REPORT OF ALTERATIONS TO DESIGNATED RESOURCE

Site Number/Address: 721 Peterson Street

Laurel School National Register Historic District

- Installation of rooftop photo-voltaic solar on the south facing roof slope of the main house and rear addition.

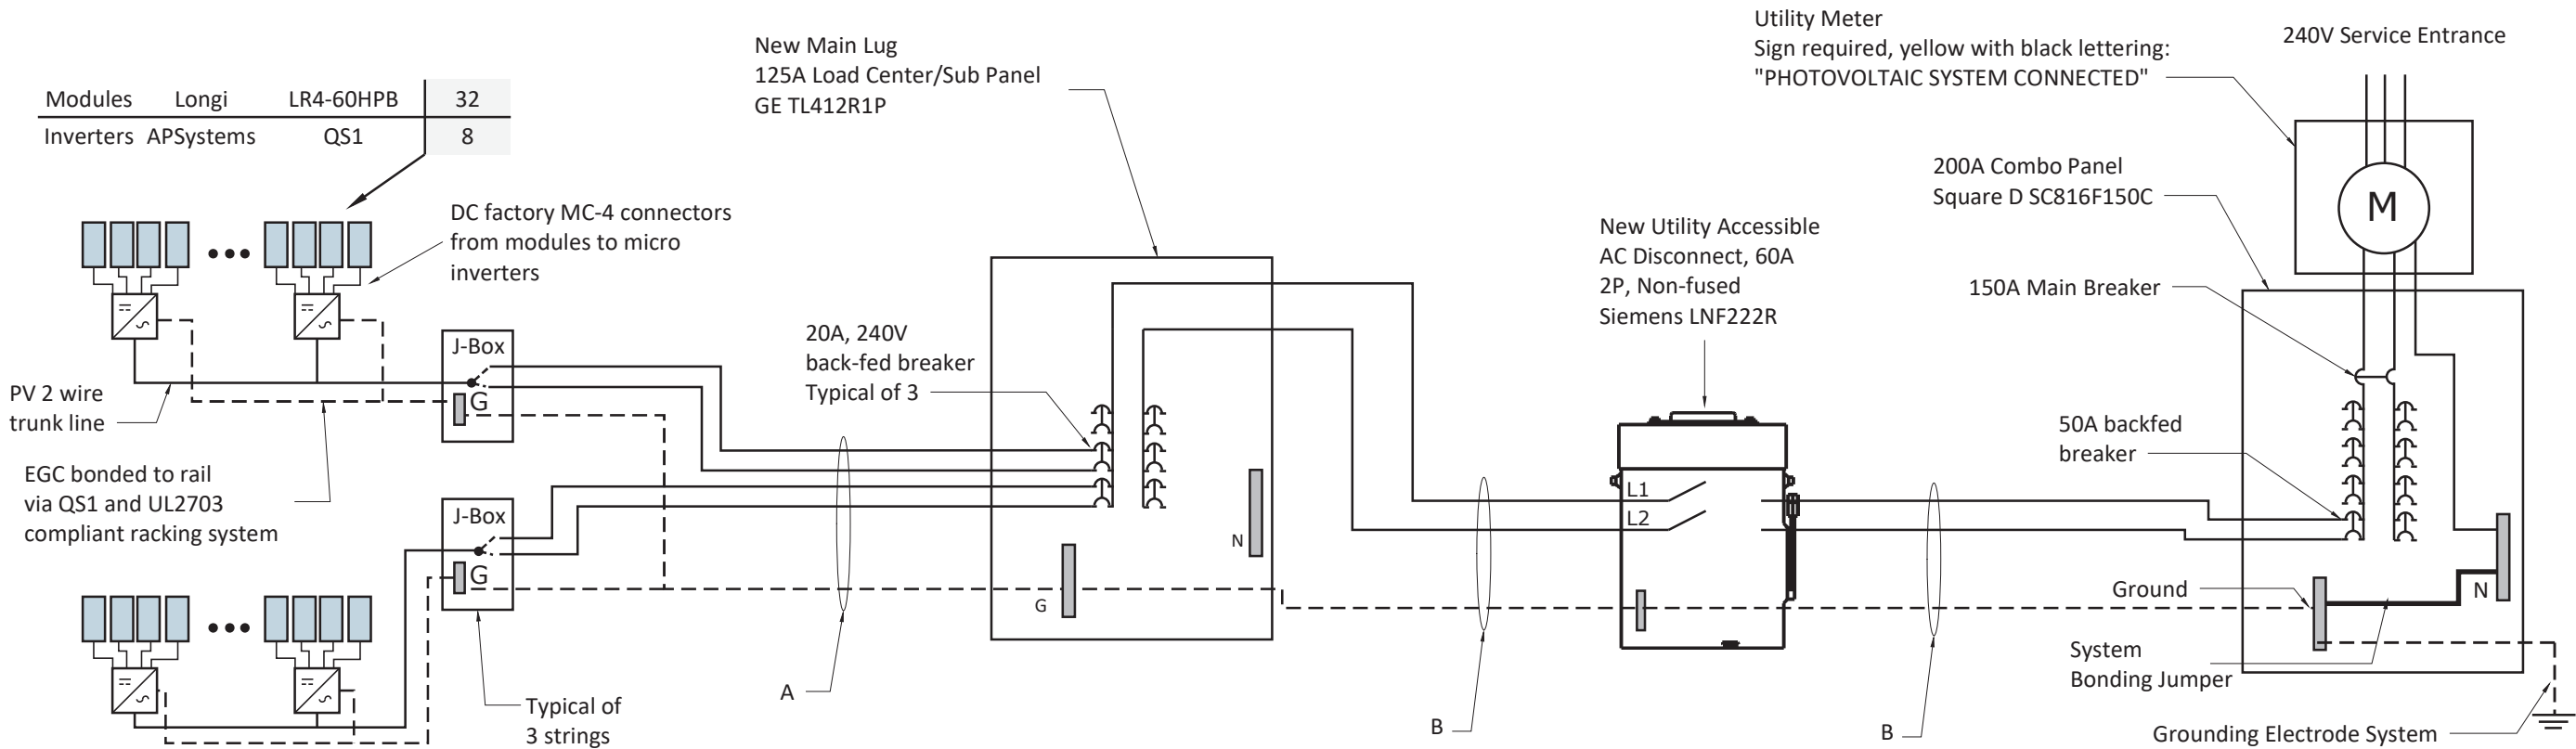
<i>missing features will be substantiated by documentary and physical evidence.</i>	
SOI #7	<i>Chemical or physical treatments, if appropriate, will be undertaken using the gentlest means possible. Treatments that cause damage to historic materials will not be used.</i>	N/A
SOI #8	<i>Archeological resources will be protected and preserved in place. If such resources must be disturbed, mitigation measures will be undertaken.</i>	N/A
SOI #9	<p><i>New additions, exterior alterations, or related new construction shall not destroy historic materials that characterize the property. The new work shall be differentiated from the old and shall be compatible with the massing, size, scale, and architectural features to protect the historic integrity of the property and its environment.</i></p> <p>As noted above, the solar panels do follow some of the guidelines for rooftop solar on residential buildings, mainly by being flush-mounted to match the roof slope. However, they are placed forward onto the front of the roof and will be comparatively visible, making them not compatible with the architectural features of the building. Staff would encourage some of the forward panels be relocated to the garage roof instead.</p>	N
